E8801A-02A

S E R V I C E N O T E

E8801A PNA Microwave Network Analyzers

Figure 2: A3 Front Panel Interface Board Assy with the Bracket Installed

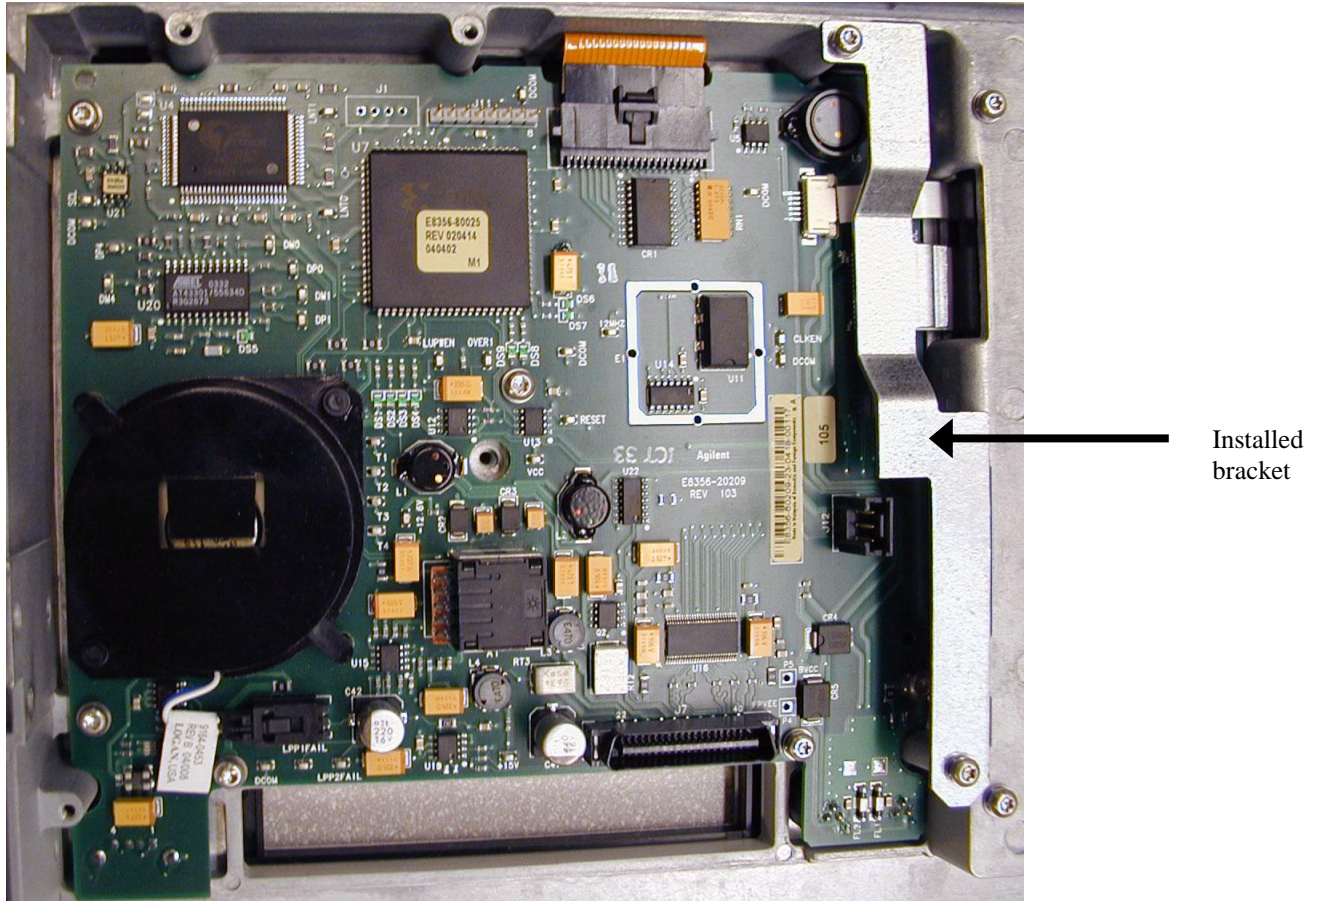
A connector of the ribbon cable (Agilent part number 8120-8409) that joins the front panel display to the front panel interface board can loosen, causing a display failure, unless a new bracket is installed. Because the failure rate has been very low, it is recommended that the bracket be installed only when there is an additional reason to remove the PNA front panel.

1. Refer to Figure 1 in this document:
 - Press down firmly on the ribbon cable's black connector.
 - Locate the two tapped holes for the bracket screws.
2. As shown in Figure 2 in this document, position the bracket so that its holes line-up with the two holes you located in the previous step.
3. Hand-start the two screws, and then torque both to 9 in-lbs.
4. Reinstall the PNA Front Panel by following the Service Guide instructions in the "Replacement Procedure." This is located on the same page as the "Removal Procedure" used previously in step 7.
